Notice of Allowability

10/791,976

EXAMINER'S AMENDMENT

Diana Lynne Gann et al. Serial No. 10/791,976
"Tampon Applicator Having a Rupturable Membranous
Cap"

Fig. 1a

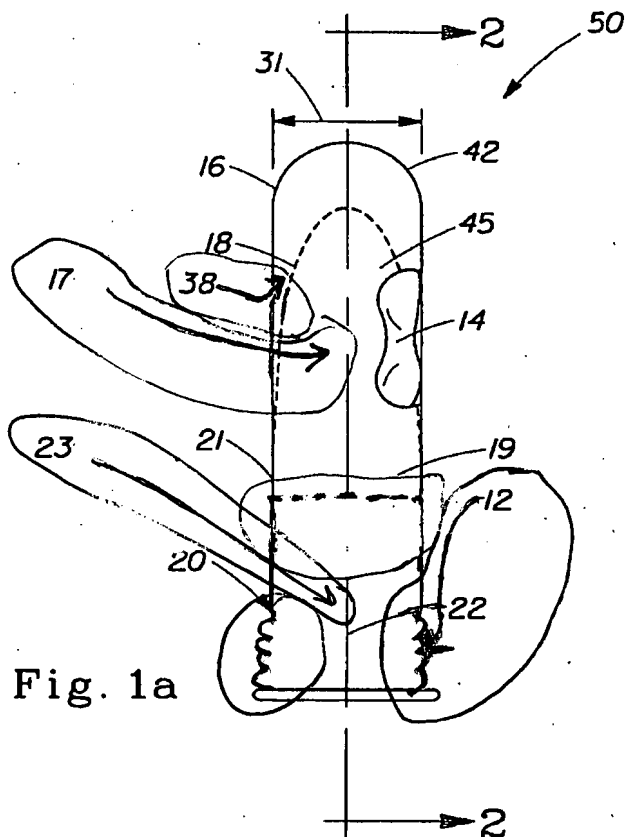
on page 3, line 22: change "cut out...axis" to --cross section view of the tampon holder tube along line 2-2 of Figure 1a in combination with a plunger--;

Fig. 6

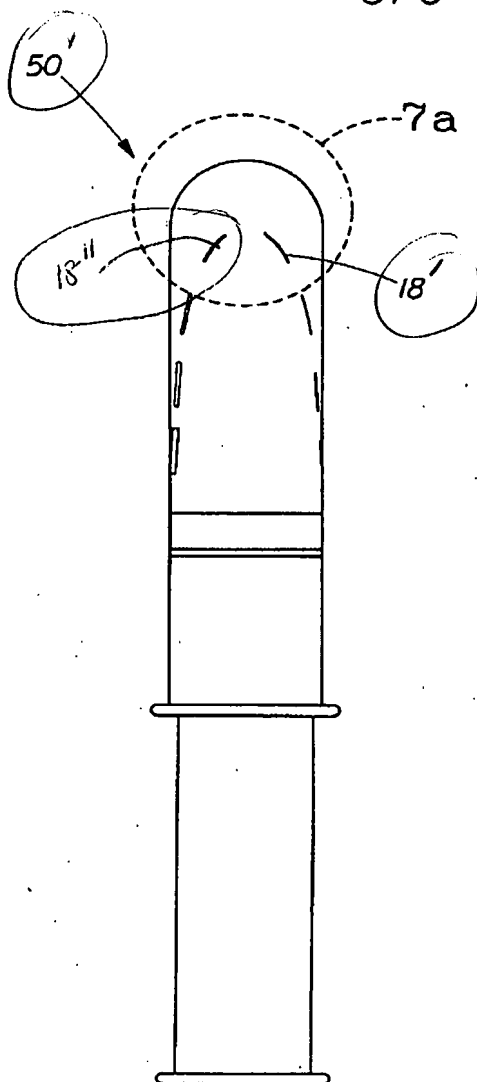
Figure 6 is an alternative embodiment of a feminine hygiene product 50'. The regions of rupture [[18]] 18', 18'' are shown. Figure 7a is a partial view 35 of Figure 6 showing the regions of rupture [[18]] 18', 18''. Figure 7b is an alternative embodiment of [[the]] a feminine hygiene product 50''. The regions of rupture 18''' are shown. Also, the plunger 13 is shown. Figure 7c shows an alternative embodiment of feminine hygiene product 50''' partially-expelling tampon

Fig. 7c

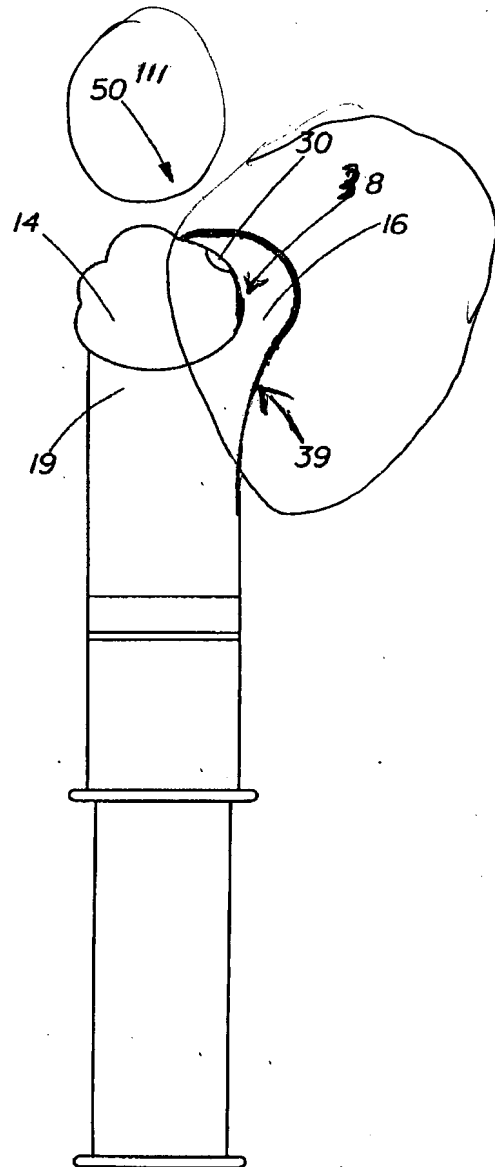
14. A portion of the feminine hygiene product 50''' comprises a rupturable membranous cap 16 comprising a projection[[s]] 30 and a hinge 39. The regions of rupture 18 [[may]] allowed a portion of the rupturable membranous cap 16 and a portion of the tampon holder tube 19 to separate.
